*Design Review Board
March 4, 2015*

MINUTES OF A REGULAR MEETING OF THE DESIGN REVIEW BOARD OF THE TOWN OF CLARKDALE HELD ON WEDNESDAY, MARCH 4, 2015, AT 6:30 P.M. IN THE MEN'S LOUNGE OF THE CLARK MEMORIAL CLUBHOUSE, 19 N. NINTH STREET, CLARKDALE, AZ.

AGENDA ITEM: DISCUSSION & POSSIBLE ACTION: DRB-091012-A sign alteration to the Copper Art Museum monument sign, located at 849 Main Street, Parcel #400-06-032B.

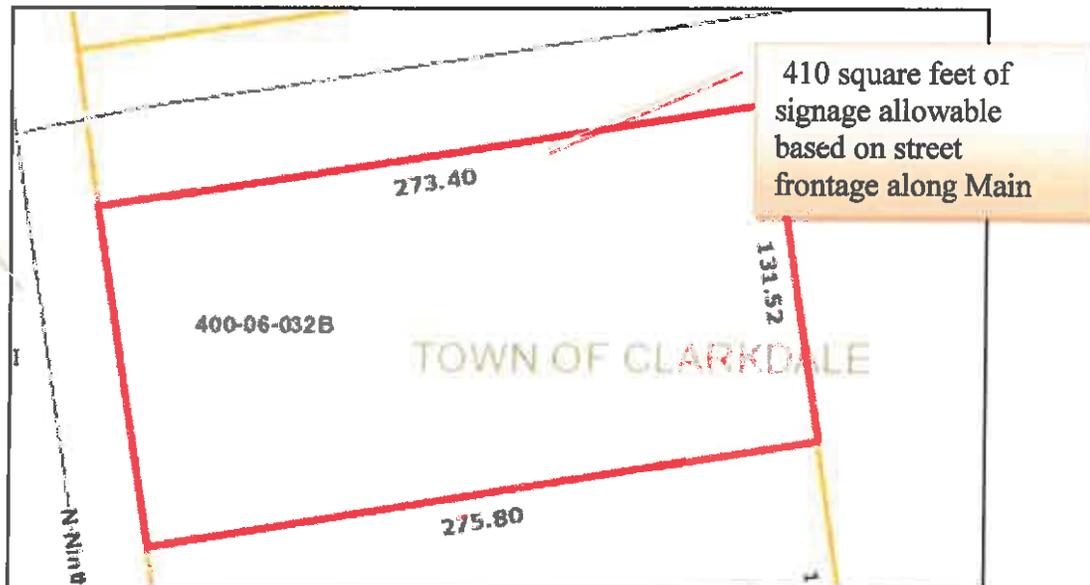
1. ***No more than three different fonts should be used in the text for the sign.*** The proposed sign has (1) font and does not exceed the suggested font counts.
2. ***Sign should have no more than 50 percent opacity. Dark background colors are preferred.*** The proposed sign complies with the new criteria, featuring iron hand cut lettering.

- 3. Signs should be non-reflective.* The proposed sign has no reflectivity.
- 4. Signs should be readable from the closest major road.* The readability of the sign complies with the new criteria.

The total square footage of new signage proposed is 52 square feet. Per the new Sign Code, Section 7-9, the applicant would be eligible for a total of 404.92 square feet of signage.

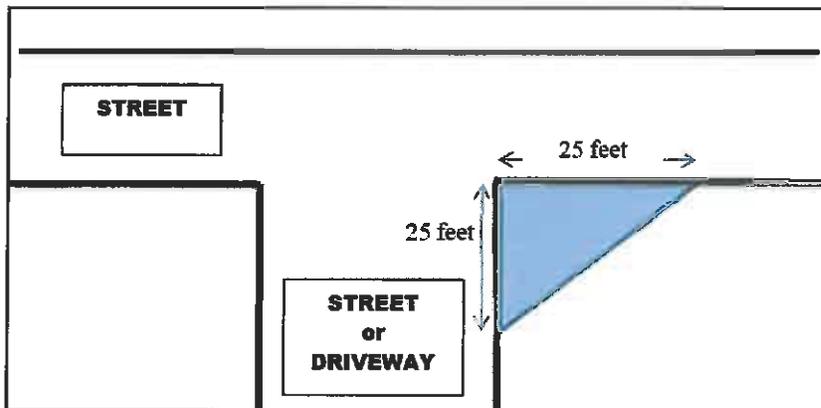
Zoning Code Chapter 7, Section 7-10 Visibility Sight Lines: To preserve visibility at intersections sight, an unobstructed view shall be maintained within these triangular areas:

- 1. At the intersection of two streets, or where a driveway or alley intersects a street, a triangle defined by measuring 25 feet in length along the curb or edge of improved roadway from their point of intersection, the Town may require more than 25 feet in high volume, high***

speed traffic areas. The proposed sign alterations will be 46' from corner of the 25' sight triangle. Application complies.

2. *No signs, except traffic signs, shall exceed a height of 30 inches above the grade of the lower roadway within the triangle area. Sign projection, or overhang, across this area shall be permitted only when the bottom of the sign is a minimum of 9 feet above grade of the higher roadway.* Application complies.
